## Douglass St. Back Yard Redesign

### ADDENDUM NO. 1 TO RFP DOCUMENTS

DATE: AUGUST 1, 2025

Prepared By:  
PORTLAND WATER DISTRICT  
225 Douglass Street  
Portland, ME 04104

**SITE PLAN- INDEX & BORING LOGS**

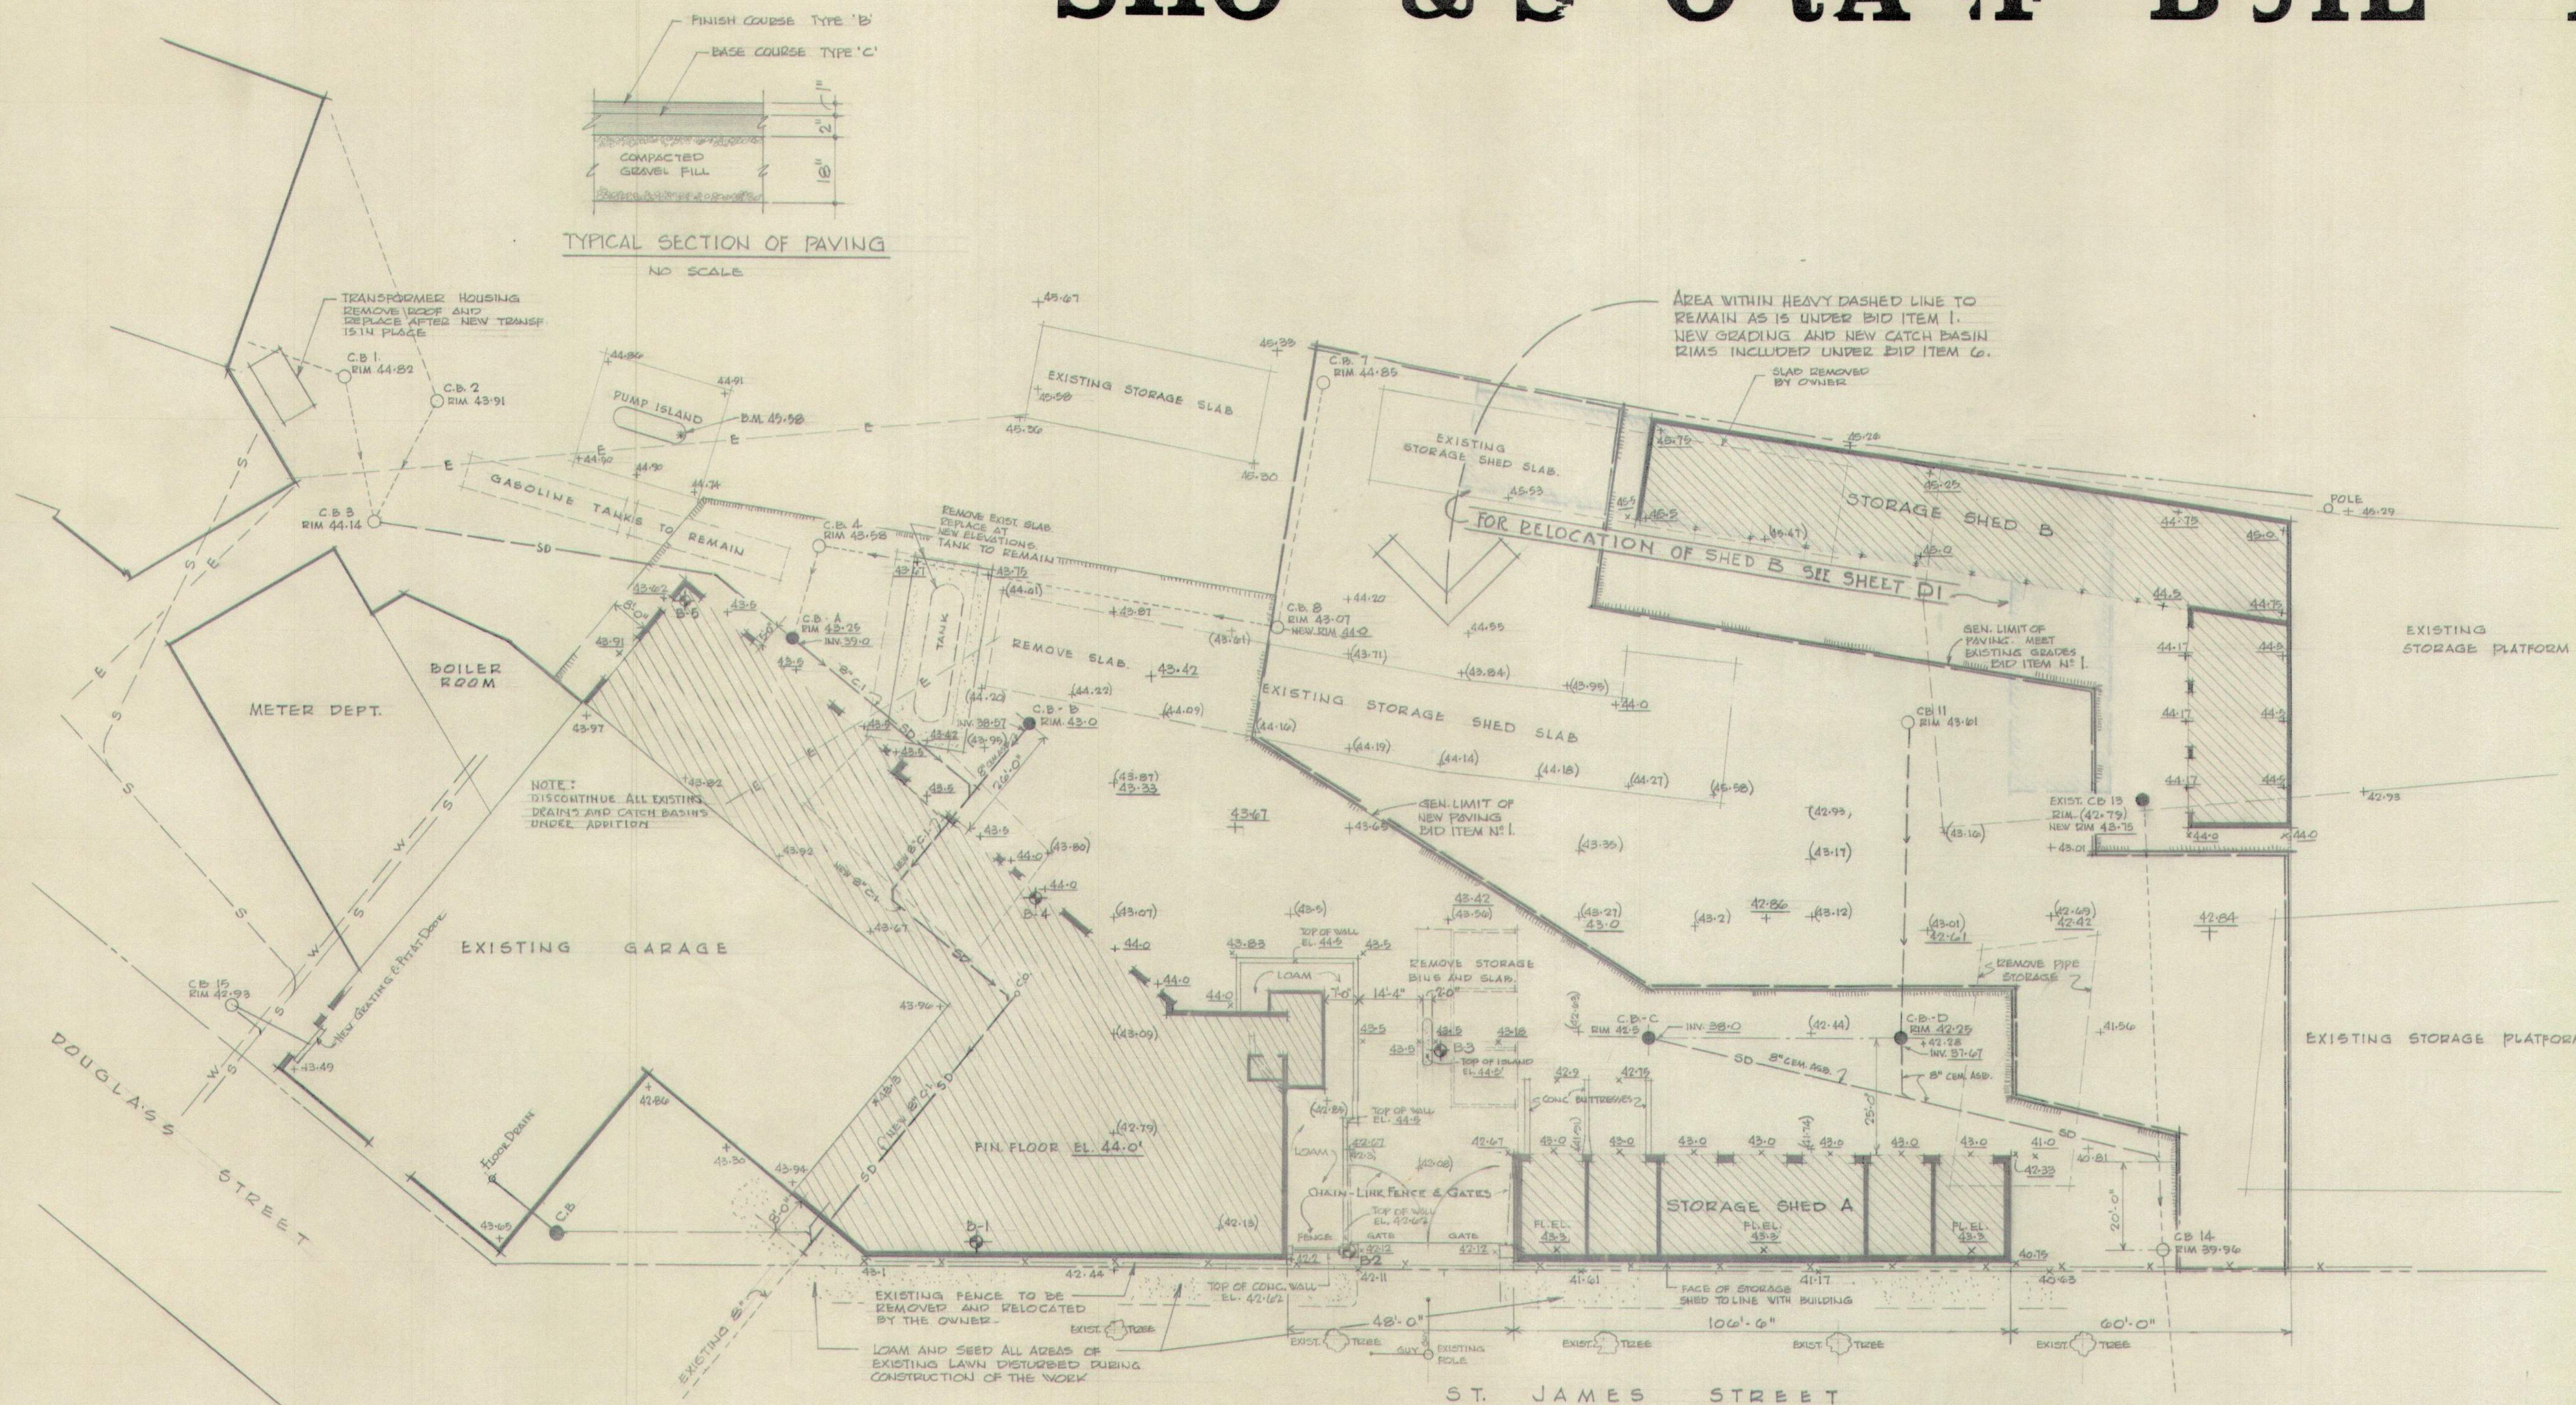
**10. Where does the site currently drain?**

- a. *See the attached plans, that contain the extent of our existing understanding.*
